Re: Contract N62470-10-D-3000
IQC for A/E Services for Multi-Media
Environmental Compliance Engineering Support
Delivery Order (DO) 0002
U.S. Naval Activity Puerto Rico (NAPR)
EPA I.D. No. PR2170027203
Revised Final Phase I of the Corrective Measures Study Investigation for
SWMU 74 – Fuel Pipelines and Hydrant Pits

NAVY RESPONSE TO COMMENT LETTER DATED MAY 27, 2010

Navy Response to EPA Comment Letter, dated May 27, 2010 and Technical Evaluation (dated May 12, 2010) of the Navy Responses to PREQB Comments on the Draft Phase I Corrective Measures Study Investigation for SWMU 74 – Fuel Pipeline and Hydrant Pits, dated November 19, 2009

FIGURE 1
SCHEDULE FOR IMPLEMENTATION OF PHASE II OF THE CMS INVESTIGATION
SWMU 74 - FUELING PIPELINES AND HYDRANT PITS
NAVAL ACTIVITY PUERTO RICO

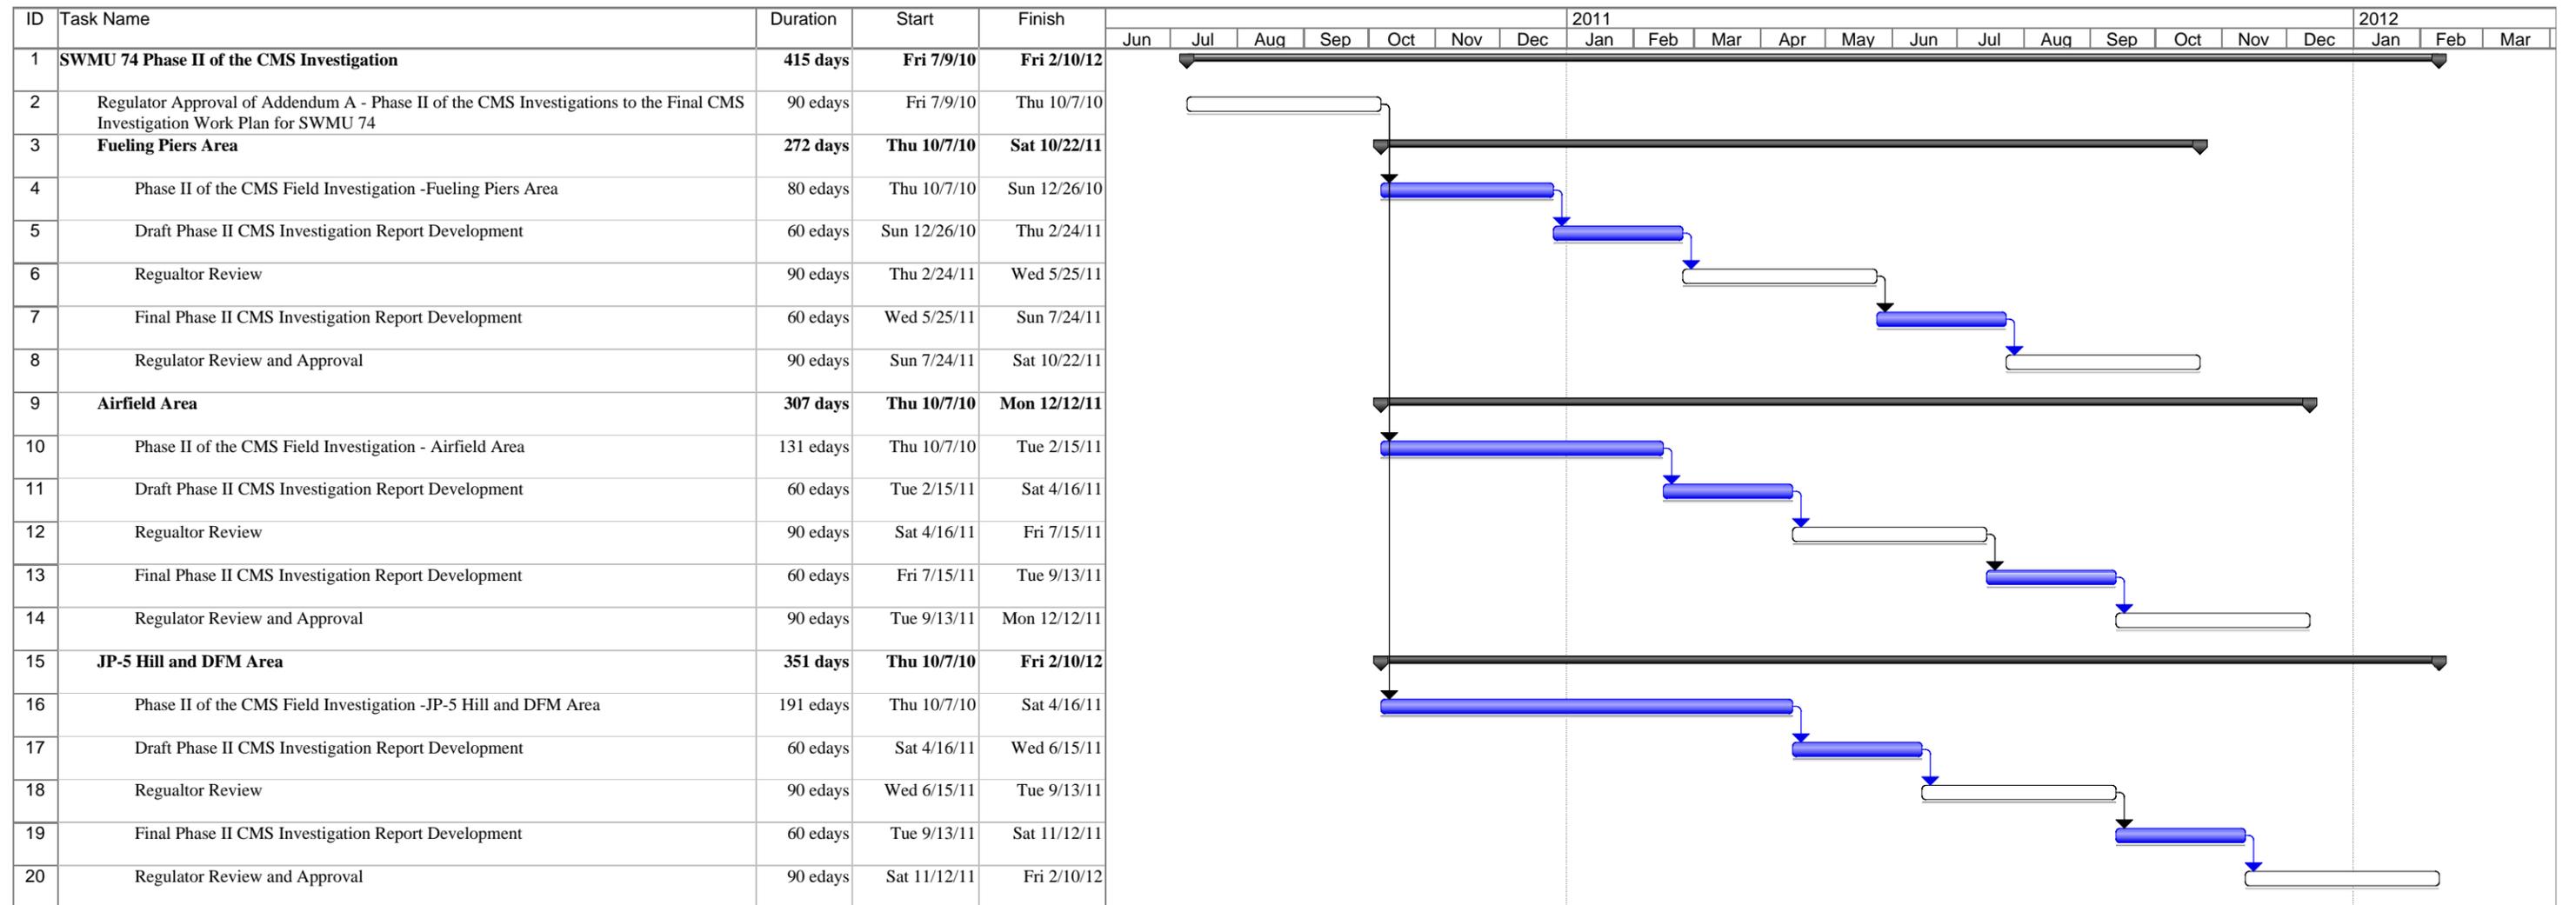
EPA has completed its review of the Revised – Phase I Report of Corrective Measures Study (CMS) and the Responses to comments (included with EPA’s letter of January 22, 2010) submitted by Mr. Mark Kimes’ (of your consultant Michael Baker Jr.) letter of March 26, 2010, on behalf of the Navy. EPA finds the Responses acceptable in regards to the issues addressed, and the Phase I Report to be acceptable as an interim report. However, EPA’s January 22, 2010 letter to you had requested that the Navy submit a work plan and schedule for implementing the Phase II CMS investigations discussed in the Phase I Report. Neither was included with the documents transmitted with the March 26, 2010 letter submitted by Mr. Mark Kimes of Michael Baker Jr., Inc. on behalf of the Navy. Therefore, EPA requests that the Navy submit, within thirty days of your receipt of this letter, a work plan and schedule for implementing the Phase II CMS investigations.

Navy Response to EPA Comment Dated May 27, 2010: A schedule for implementing Phase II of the CMS investigation is attached to this Response to Comments as Figure 1. Note that the Phase II activities will be implemented by geographic area (Airfield Area, SWMU 9 Area A/B, JP-5 Hill and DFM Area, SWMU 9 Area C and the Fueling Piers Area) and as funding becomes available. Phase II activities for the Airfield Area, JP-5 Hill and DFM Area, and the Fueling Piers Area are currently funded; Phase II activities for SWMU 9 Area A/B Area and SWMU 9 Area C Area have not yet been funded.
